23 August 2022

Mitchell Isaacs  
Chief Knowledge Officer  
Department of Planning and Environment: Water  
Locked Bag 5022  
PARRAMATTA, NSW, 2124

**Western Coal Services (SSD 5579) – MOD 4 RTS**

## Springvale Coal Services Existing Water Management System

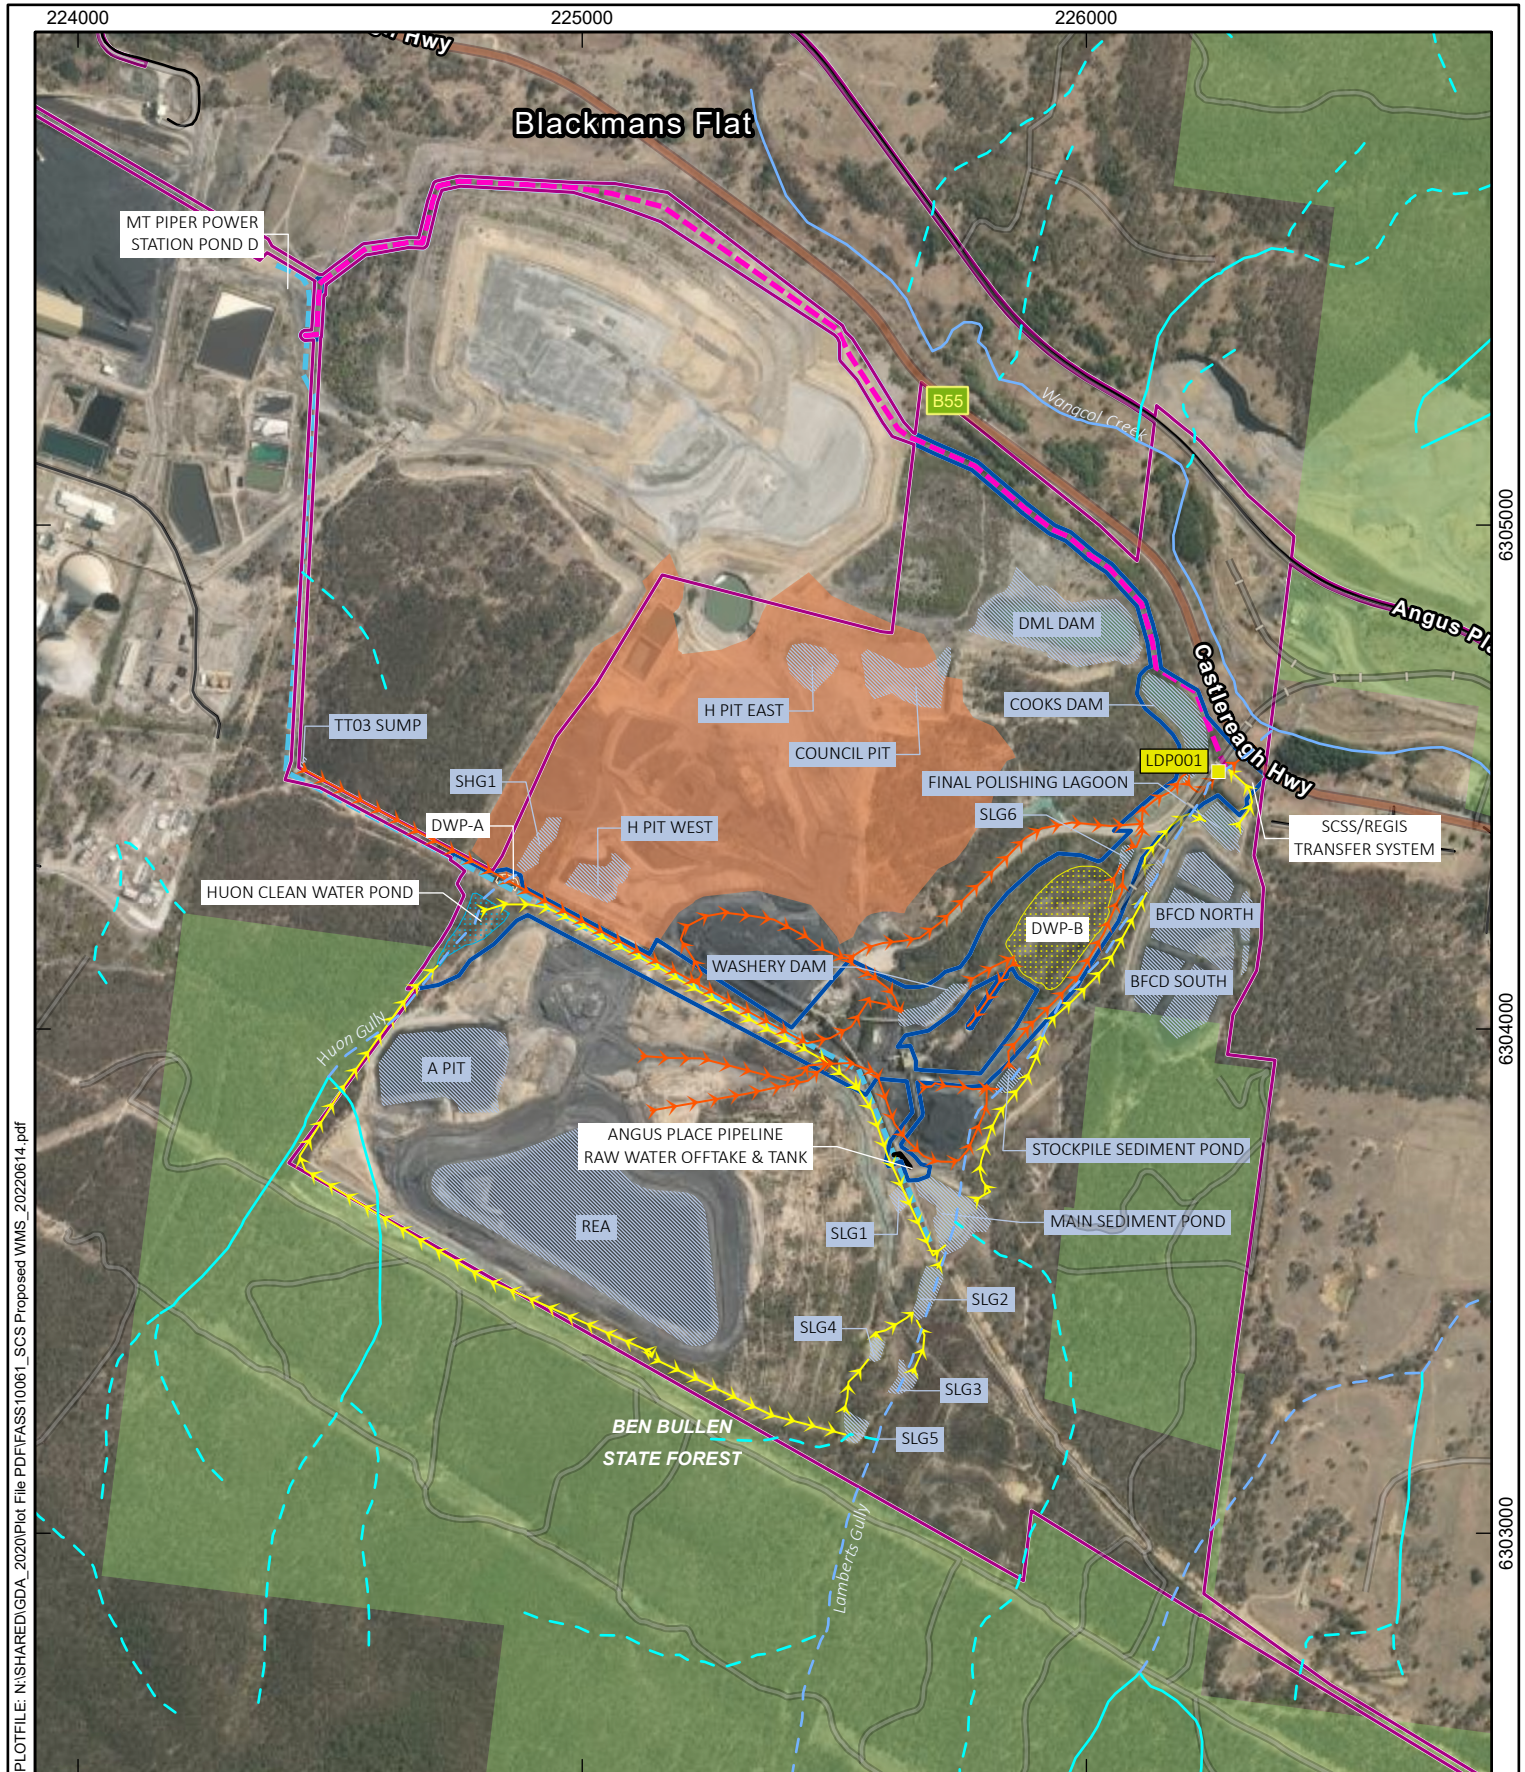
**Information Request** – that the proponent provides further clarification on the management of clean and dirty water separation from the Huon Clean Water Pond into Lamberts Gully. This is to assist in addressing a query originally raised on review of the EIS.

If the water diverted from the Huon Clean Water Pond is clean, it is recommended it be diverted directly into a clean section of Lamberts Gully. Alternatively, if all water captured in the Main Sediment Basin is clean, further clarification is required.

The figures described above are in error. The existing water management system should show clean water captured within and cascading through SLG5, SLG4, SLG3, SLG2 and then into the Main Sediment Dam and clean water flowing in a south easterly direction around the toe of the rehabilitated area to the east of the REA, into SLG1 and then into Main Sediment Dam. In summary, only clean water reports to the Main Sediment Dam. Centennial presented this correction in its Response to Submissions Report, however, further clarification was requested by DPE-Water. To that end, Centennial presented the above mentioned correction and provided a detailed explanation to better clarify the errors during its meeting with DPE-Water and the DPE on 18 August 2022. The pertinent slides presented at this meeting are provided in **Attachment 1**. The corrected surface water management figure is presented in **Attachment 2**.

We can confirm that water captured in the Main Sediment Basin is clean. Figures 3.1 and 3.2 (and Figure 5.1 of Appendix A) within the Modification Report presented (amongst other things) the existing surface water management system at the SCSS. Figure 4.2 (and Figure 5.3 of Appendix A) within the Modification Report presented (amongst other things) the proposed surface water management system. The five figures were drawn to show that dirty water is captured within and cascades through SLG5, SLG4, SLG3, SLG2 and then into the Main Sediment Dam. Furthermore, the five figures showed that dirty water flows around the toe of the rehabilitated area to the east of the REA, into SLG1 and then into Main Sediment Dam.
